Updates since Vancouver on BDS and MDI

LCD Study Group meeting at SLAC

Andrei Seryi

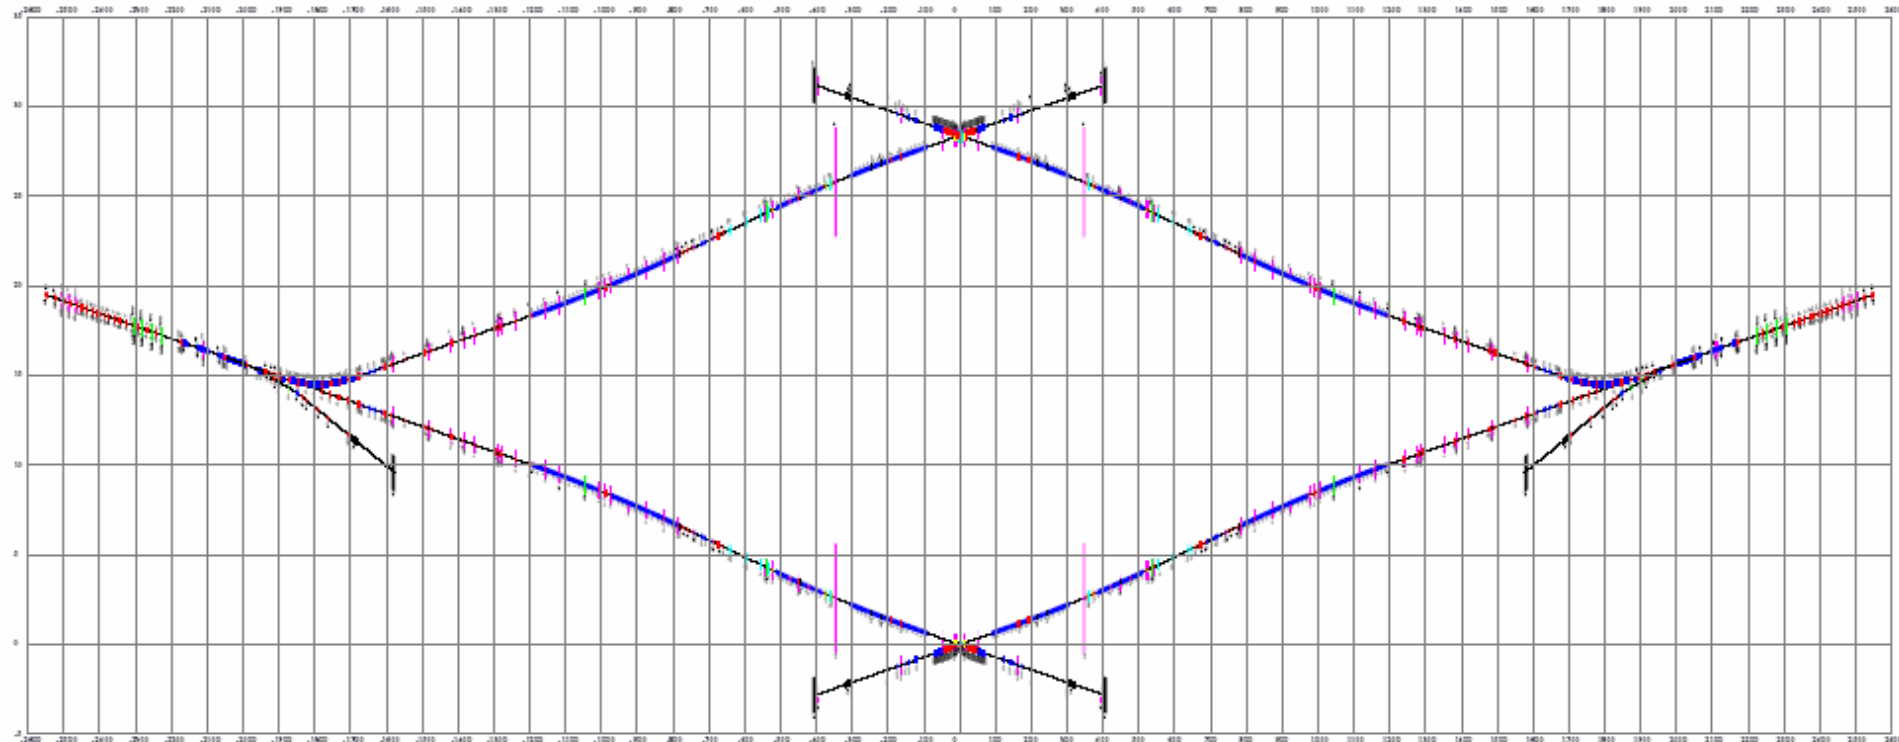
- CCR (configuration change request) submitted for 14/14 configuration with single collider hall at $z=0$
 - **under review now by CCB (Change Control Board)**
- Under discussion: CCR for on surface detector assembly
- Under discussion: CCR for changing two muon walls (9m+18m) to single 5m muon wall

- About 5.1km from end to end
- 28.4m transverse separation of IPs
- Shortening the extraction lines is being implemented

Layout as of Vancouver

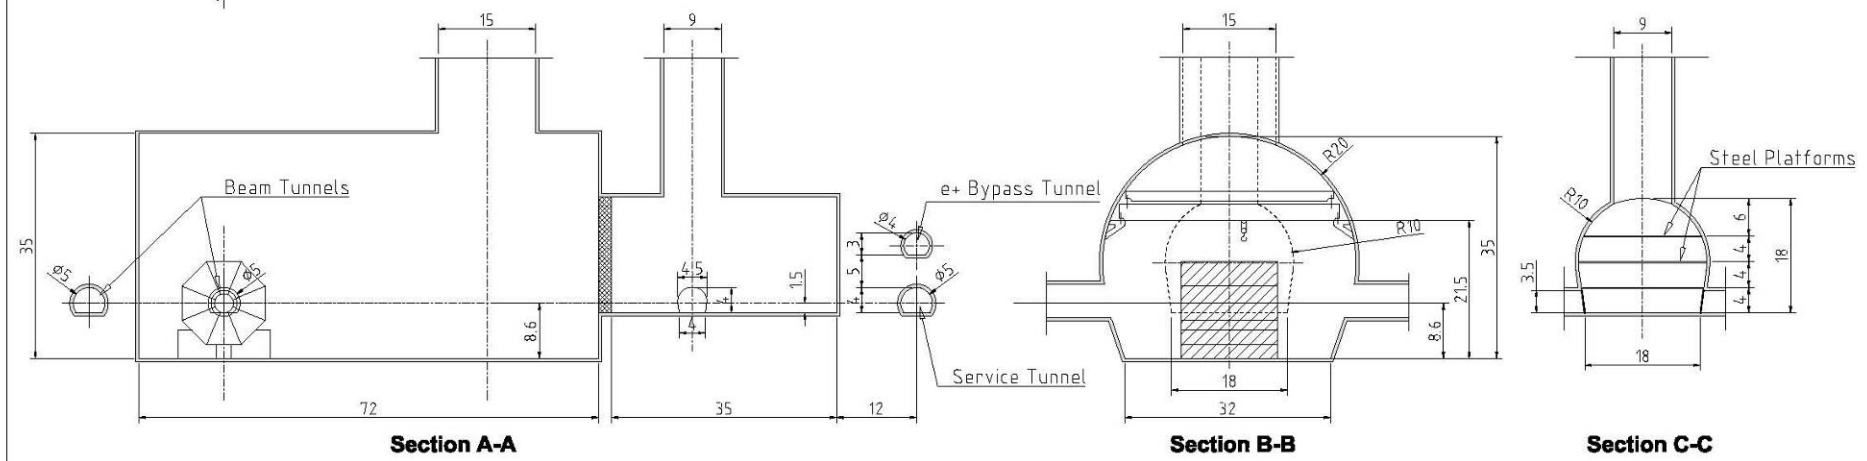
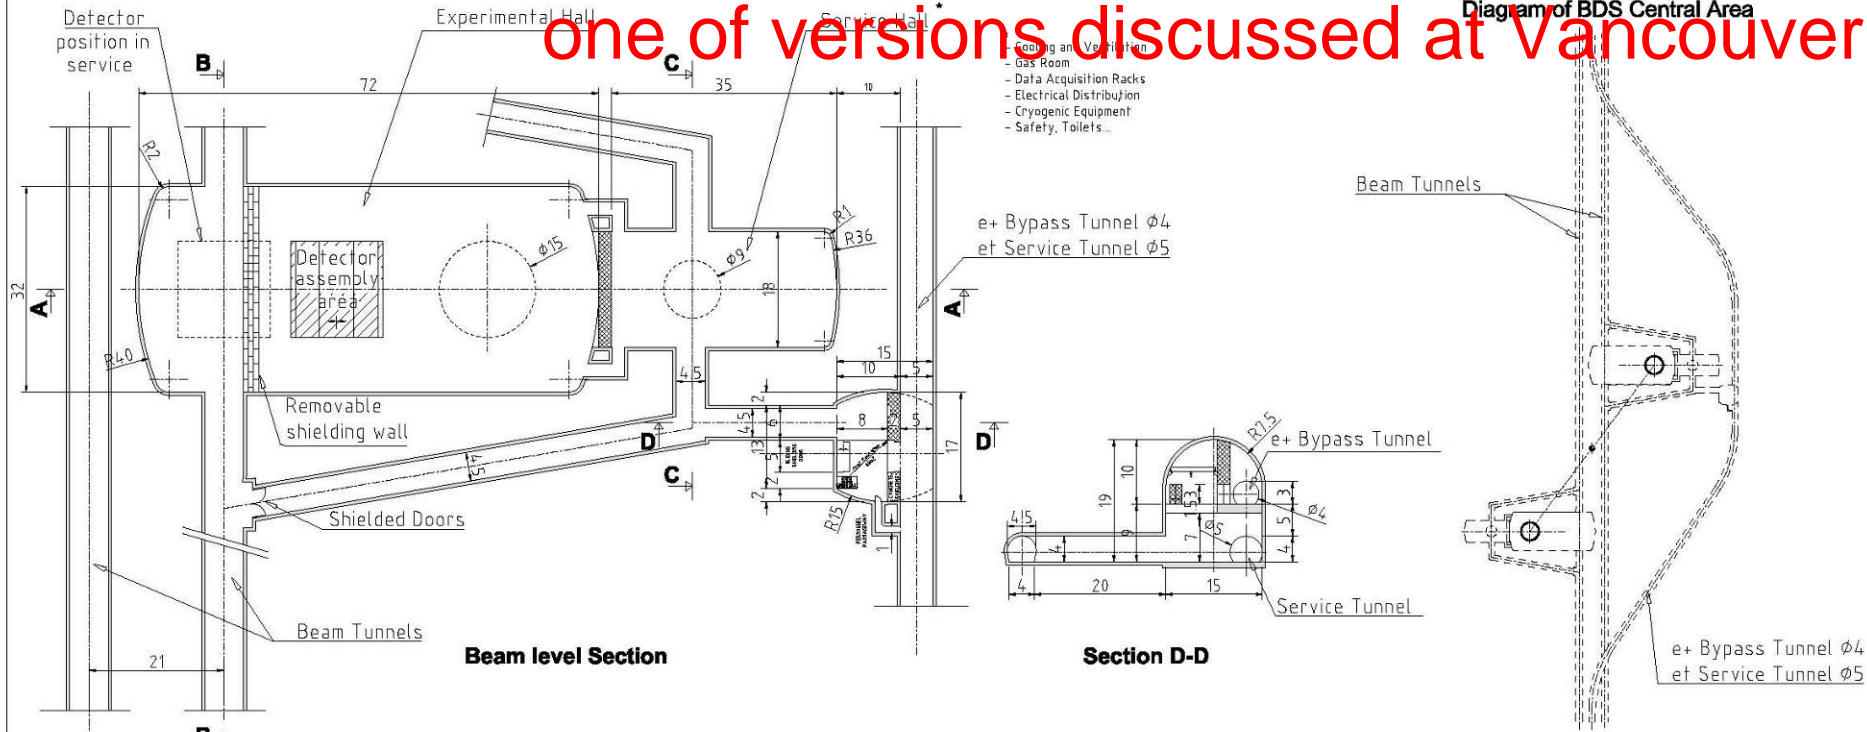
- Re-evaluating the cost of service tunnel (in BDS as well as in linac)
- Considering 4m tunnel in BDS and alcoves
- Tentatively, assumed 30W*100L*35H single collider hall
 - **reducing the size and number of access shafts can give savings**
 - **next pages shows layout discussed at Vancouver**

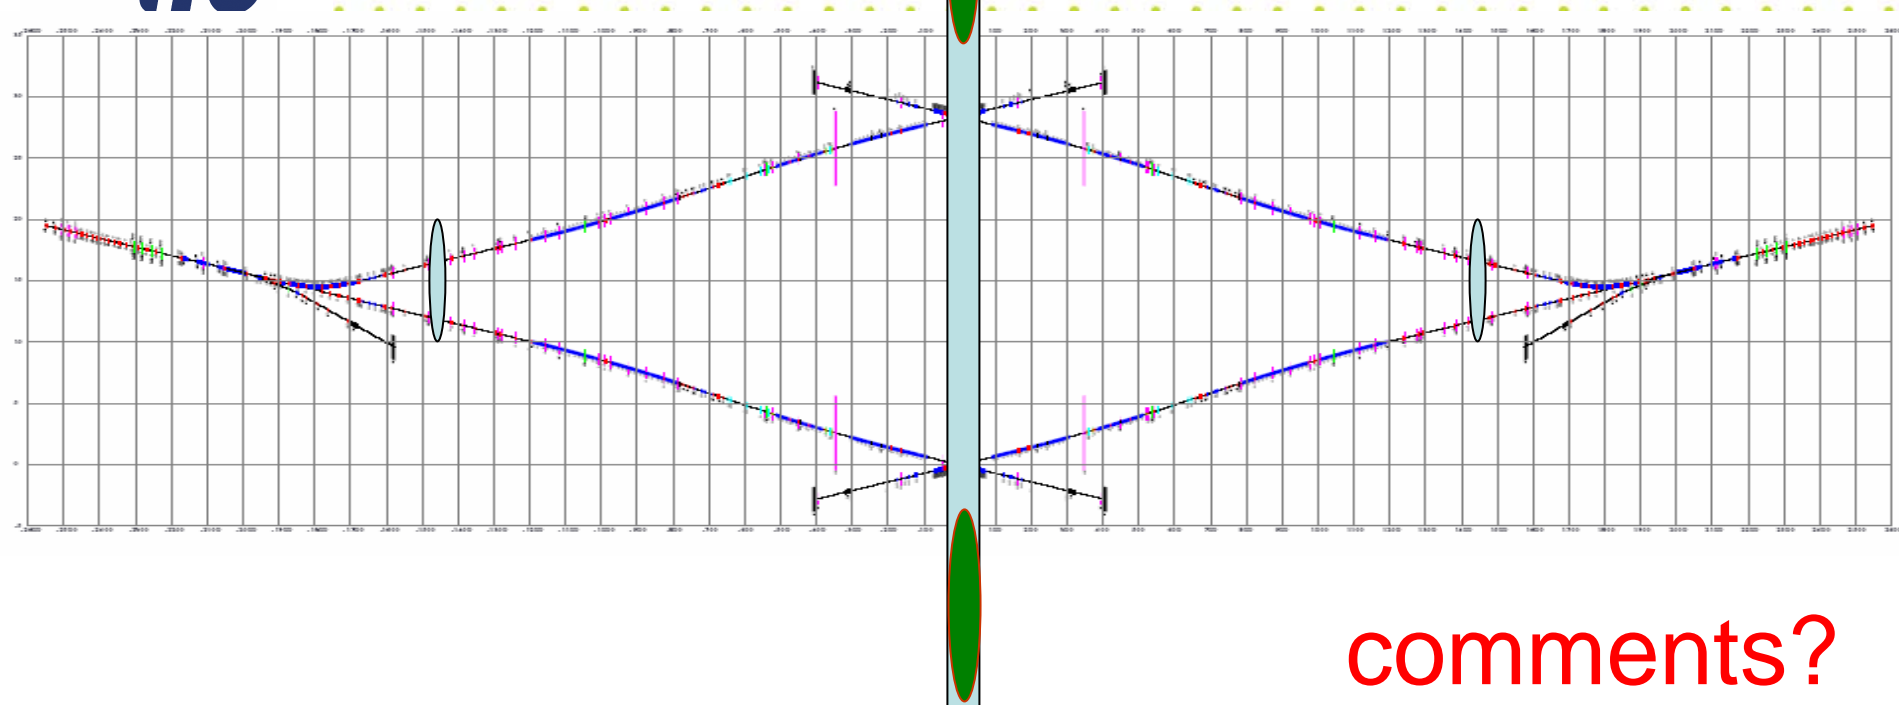
- Discussing moving out the 9m shafts to BSY
- Equipping the 15m detector hall shafts with elevators for personnel

comments?

- 4m tunnels in BDS with alcoves, no service tunnel
- tentatively, 30W*100L*35H single hall
- e+ bypass ignored
- 9m shafts in BSY for accelerator
- 15m shafts in detector hall with elevators & stairs
- no cover on top of 15m shafts
- no additional detector caverns for equipment
